UNITED STATES PATENT AND TRADEMARK OFFICE

APPLICATION NO.	FILING DATE	FIRST NAMED INVENTOR	ATTORNEY DOCKET NO.	CONFIRMATION NO.
10/815,922	04/02/2004	Hideki Tominaga	D-1587	9419

Office Action Summary

DETAILED ACTION

attachment # 1
(office action 03/07/06)

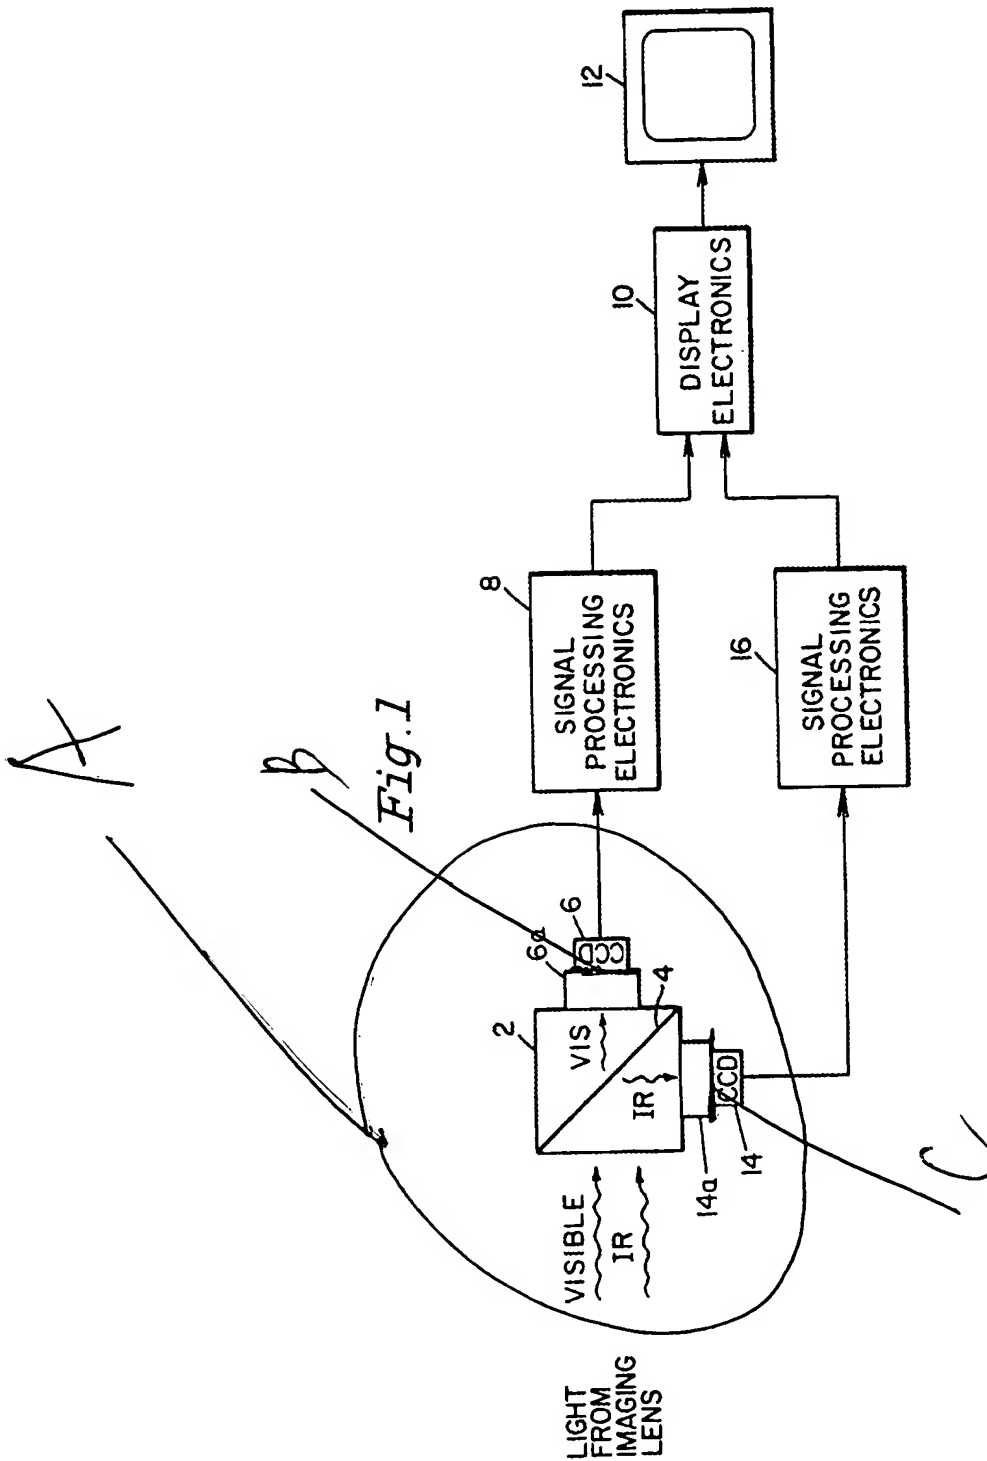
Fontenot discloses in Figs. 1, 7 a device/ assembly/ one image pickup device A for directing a visible (first wavelengths) and IR (second wavelengths) rays from a light diverging/ separating means 4 (or 84) and having a light receiving surface having two light receiving areas B and C at 90 degree to each other and comprising CCD chips 6 and 14 (plurality of two dimensionally arranged micro-photo-elements). An imaging lens directing light to said light receiving areas, wherein a first area B of the light receiving

surface is designated for first wavelengths (visible light) and a second area C is designated for second wavelengths (IR). The light diverging means comprises a prism 2 having two edges (two prism surfaces, thus, acting as two prisms), the edges (two prisms) are equipped with a (first) filter 4 to block IR and a (second) visible light blocking filter 14a, the filters 4 and 14a (or 90, 86) constituting a wavelength limitation means located in front of said areas of the image pickup device and directing said visible light and said IR to their respective first and second areas (col. 2, lines 65-67 and col. 3, lines 1-7). The device also comprises a display where the images corresponding the two wavelengths are recombined and displayed. This would imply, that the device comprising some means (processing electronics 8, 16/ temperature calculating means) for processing images and making them understandable for an operator in terms of at least IR/ thermal image, which is representative of temperature of the object of interest. (The numerals A-C have been added by the Examiner, see attachment # 1 to the Office Action).

Also, the "image pick up device" does not necessarily means a CCD camera. Thus, in the new rejection, the Examiner interprets Fontenot' s structure A as being a "one image pick up device" having two "light receiving surface areas" B and C as parts of the CCD chip 6 and the CCD chip 14 respectively. Please note, that according to Figs. 1 and 7 of Fontenot, all these elements are parts of the "one image pick up device" A.
